Location:	Jack London Square Development Project: Sites D at Broadway and F2 at Harrison Street (south of Embarcadero). (see map)
Assessor's Parcel Numbers:	018 041500101
Proposal:	Final Development Permits for Sites D and F2.
Applicant:	CIM Group, Sean Buran: p: (323) 860-1811
Contact Person:	CIM Group, Sean Buran: p: (323) 860-1811
Owner:	CIM Group
Case File Number:	PUD13170-PUDF-01 and -02
Planning Permits Required:	Final Development Permits for Sites D and F2 of Jack London Square Planned Unit Development Project; Minor variance to reduce parking.
General Plan:	Site D=Retail, Dining and Entertainment-1; and Site F2=Waterfront Commercial Recreation-1.
Zoning:	C-45 Community Shopping Commercial Zone
Environmental Determination:	Final EIR certified on March 17, 2004 by the Planning Commission; Addendum #1 approved on September 23, 2014.
Historic Status:	None for affected sites.
Service Delivery District:	I – Downtown/West Oakland/Harbor

SUMMARY

CITY OF OAKLAND PLANNING COMMISSION

Case File: PUD13170-PUDF-01 and -02
Applicant: CIM Group, Sean Buran
Address: Jack London Square Development Project: Sites D at Broadway and F2 at Harrison Street (south of Embarcadero)
Zone: C-45

COLOR SCHEME COMPARISON
PLANNING COMMISSION HEARING
Jack London Square - Parcel D
CIM Group

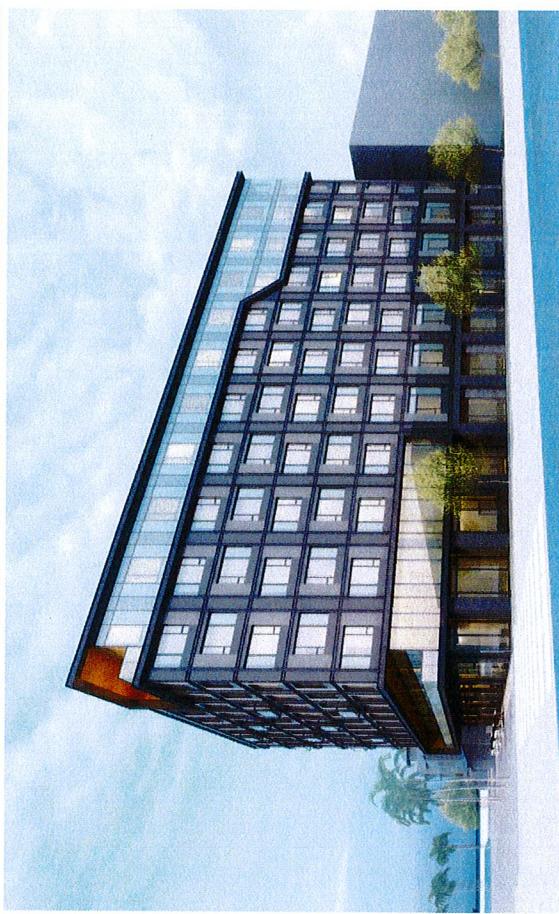
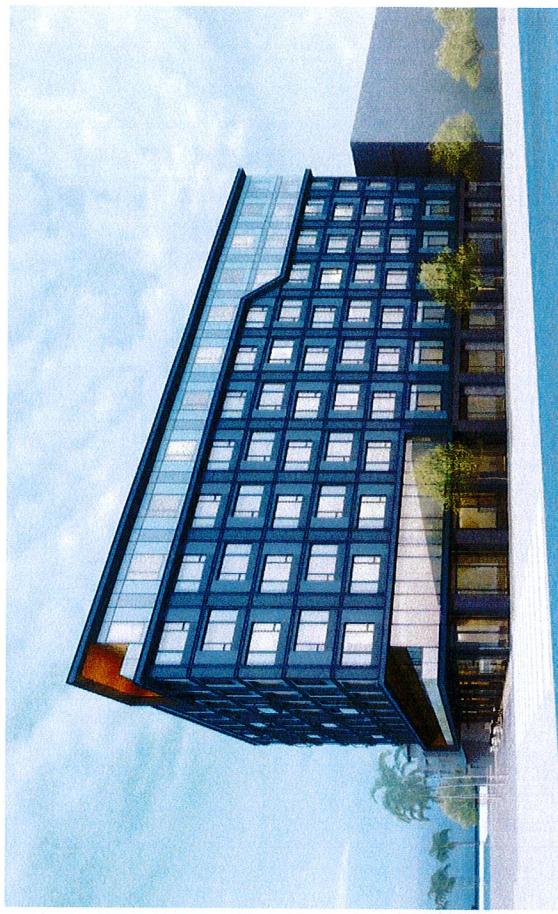
- Water Street should be fully designed and implemented as part of the Site F2 improvements.
- Site D:
 - The base color is very dark. A brighter, lighter color would make more of a landmark statement at this important site.

The D2 site is well-designed with a dynamic roof line, dramatic soffit detailing and large expanses of glazing. However, the dark base color of the building is cool and recedes into the background. The D2 site is a gateway site in Oakland. The building at that site should have a signature, welcoming color scheme that reflects its location on the Oakland waterfront and near the Port of Oakland. Staff recommends that the Planning Commission direct staff to work with the applicant to refine a unique, signature exterior color palette that reflects the prominence of the Site D location and location adjacent to an active port on a prominent waterfront.

CIM
WATER STREET SECTION
PLANNING COMMISSION HEARING
Jack London Square - Parcel F2
CIM Group

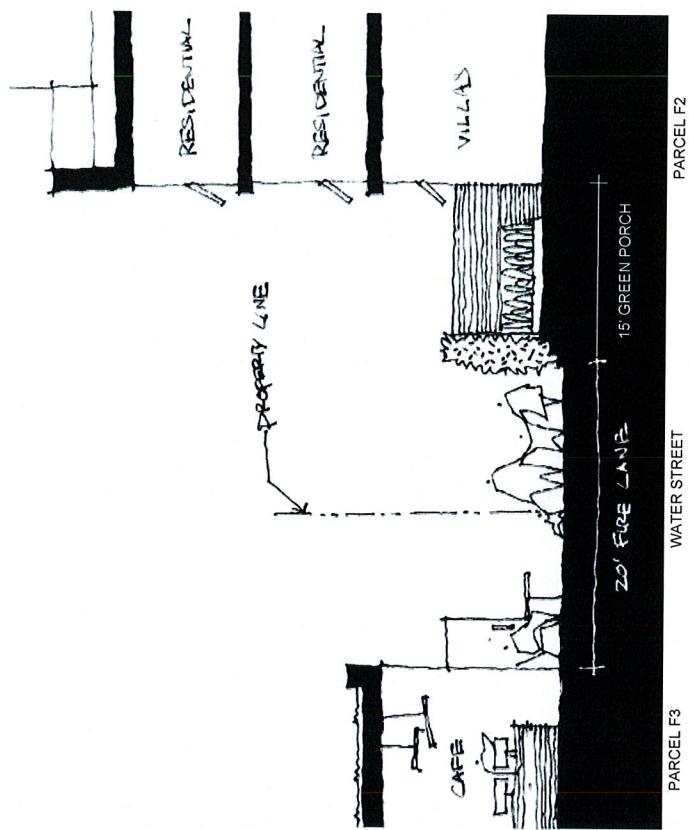
time, the applicant has provided images suggesting the design intent for Water Street. Staff recommends that the Planning Commission direct staff to work with the applicant to ensure delivery of Water Street improvements consistent with the design intent reflected in the plans.

- Direct staff to work with the applicant prior to issuance of construction-related permits to ensure delivery of the following items:
 - Water Street improvements to be consistent with design intention indicated on plans;

NORTH (EMBARCADERO) ELEVATION
PLANNING COMMISSION HEARING
 Jack London Square - Parcel F2
 CIM Group

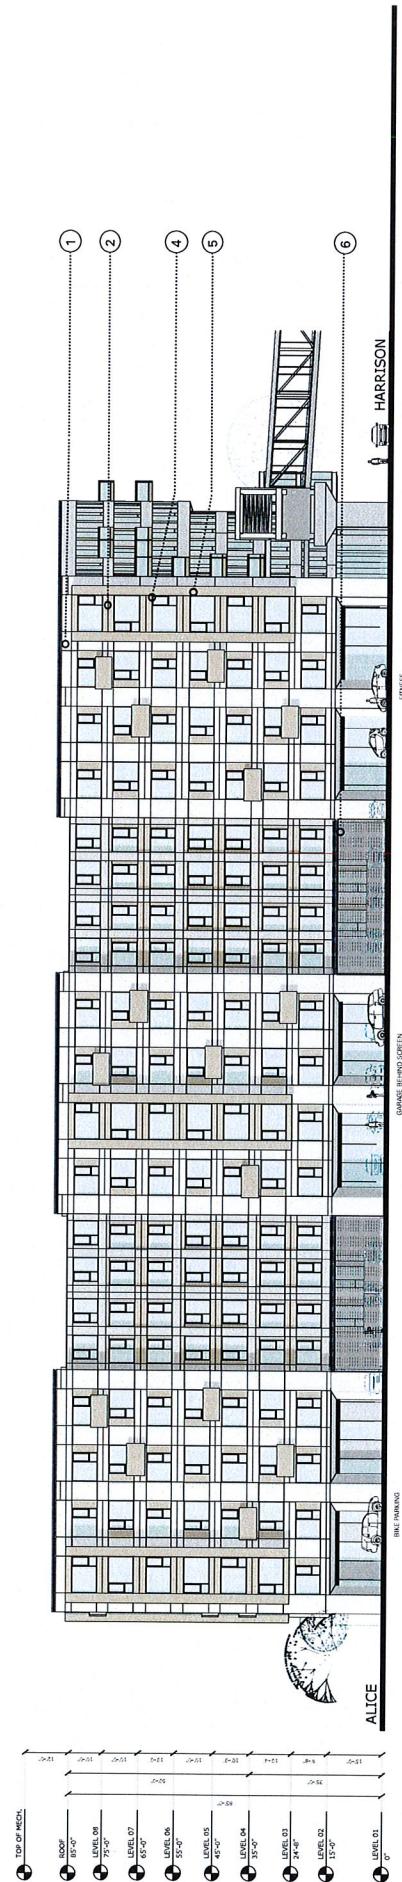
- Site F2:
 - Dark color on Embarcadero façade could be lightened and reflect materials used throughout the project, instead of introducing an entirely new material.

- Ground floor along Embarcadero should be enlivened with lighting, storefront-style display windows and otherwise made less imposing and monotonous for pedestrians.

In general, the F2 building is well-articulated and responsive to the conditions on each side of the proposed building. The applicant has revised the façade facing Embarcadero to reduce mass and monotony. Staff recognizes that to address the noise condition adjacent to the very active railroad right-of-way adjacent to the Embarcadero building elevation is difficult without minimizing the articulation and openings on that side of the building. Staff believes that the current design iteration maximizes articulation and openness while ensuring compliance with building codes. However, the ground floor of the building is imposing and uninviting to passersby. Staff recommends that the Planning Commission direct staff to work with the applicant to reduce the appearance of the parking garage along the ground floor, and to soften the pedestrian experience with lighting, landscaping and visually interesting experiences that could include storefront display windows, murals or other forms of public art.
